RE: SITE PLAN (SP2018-020), Chick-Fil-A

Project Number: SP2018-020
Project Name: Chick-Fil-A
Project Type: SITE PLAN
Applicant Name: WIER & ASSOCIATES, INC
Owner Name: CHICK-FIL-A
Project Description:

SITE PLAN
CHICK-FIL-A #03897
SOUTHWEST CORNER OF N. LAKESHORE DR. & GOLIAD ST.

B2 REAR ELEVATION
 1/4" = 1'-0"

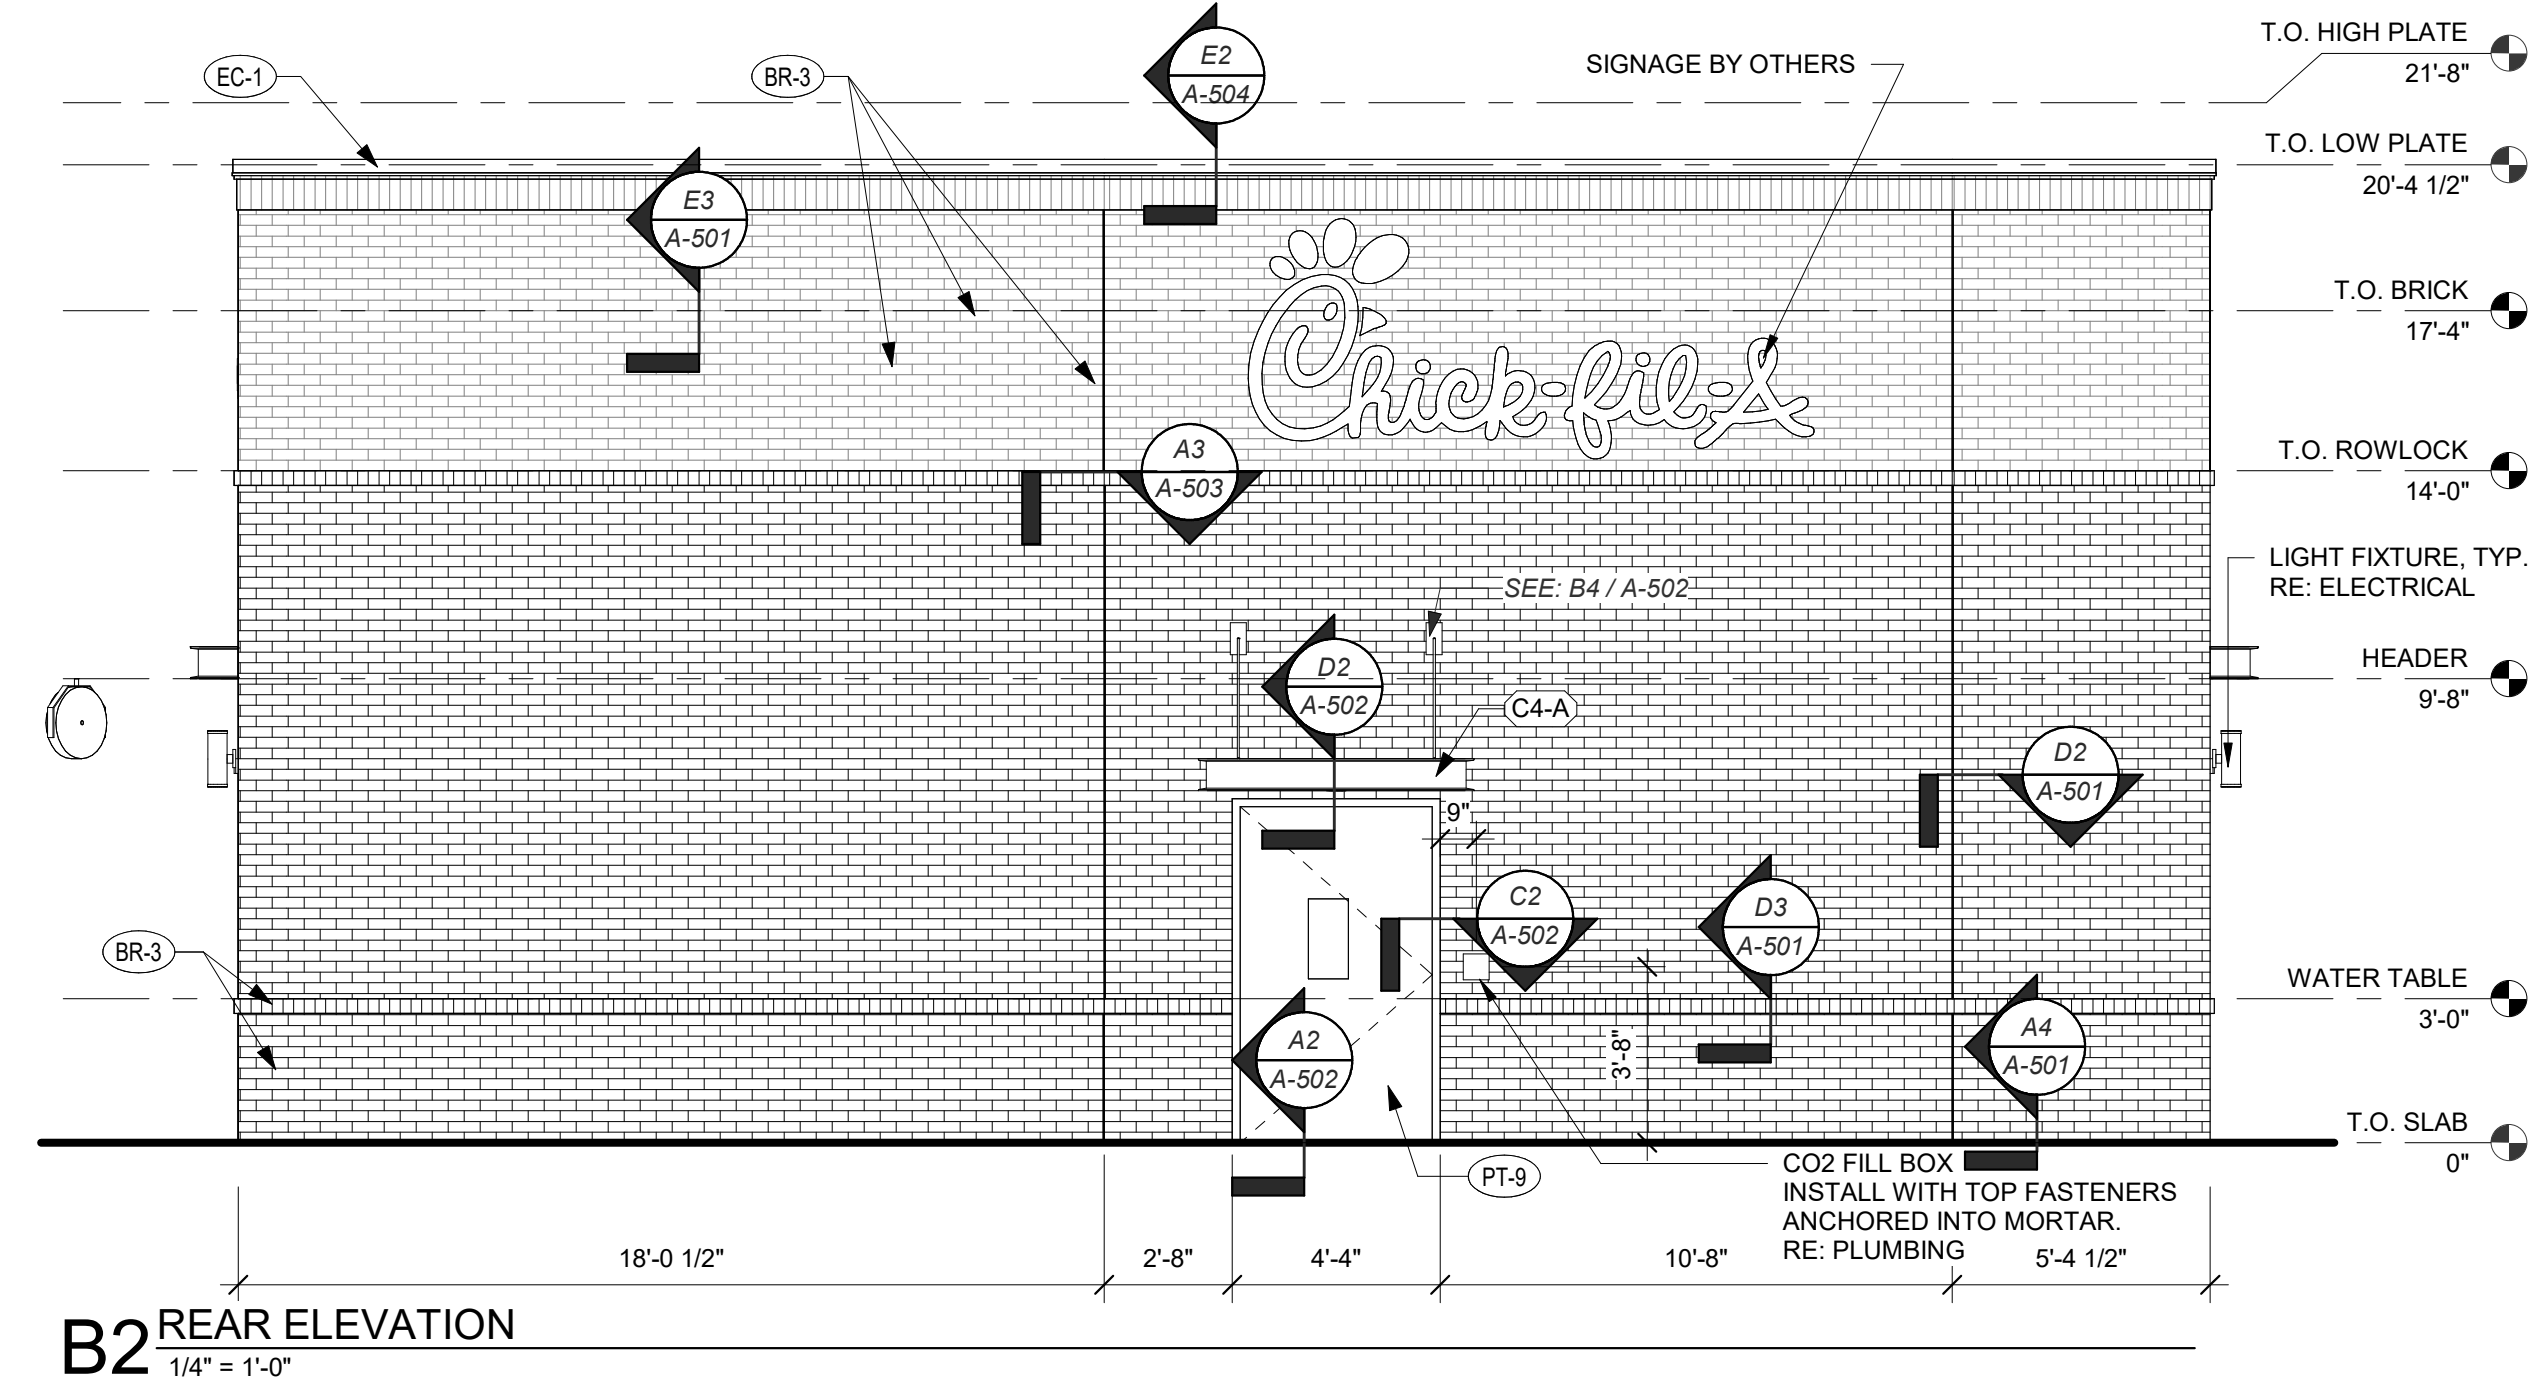
On July 31, 2018 the Architectural Review Board (ARB) reviewed the proposed building elevations and request more vertical and horizontal articulation and revisions to the color of brick and to add stone to blend with the rest of the commercial development. In addition, the Architectural Review Board (ARB) expressed agreement with the requested variance to the pitched roof requirement. The Architectural Review Board (ARB) will review the revised building elevations and forward a recommendation to the Planning and Zoning Commission at the August 14, 2018 meeting.

On August 14, 2018, the Architectural Review Board (ARB) reviewed the revised building elevations and the motion to approve the building elevations and recommend approval of the variance to the pitched roof requirements passed by a vote of 6-0 with Board Member Mitchell absent.
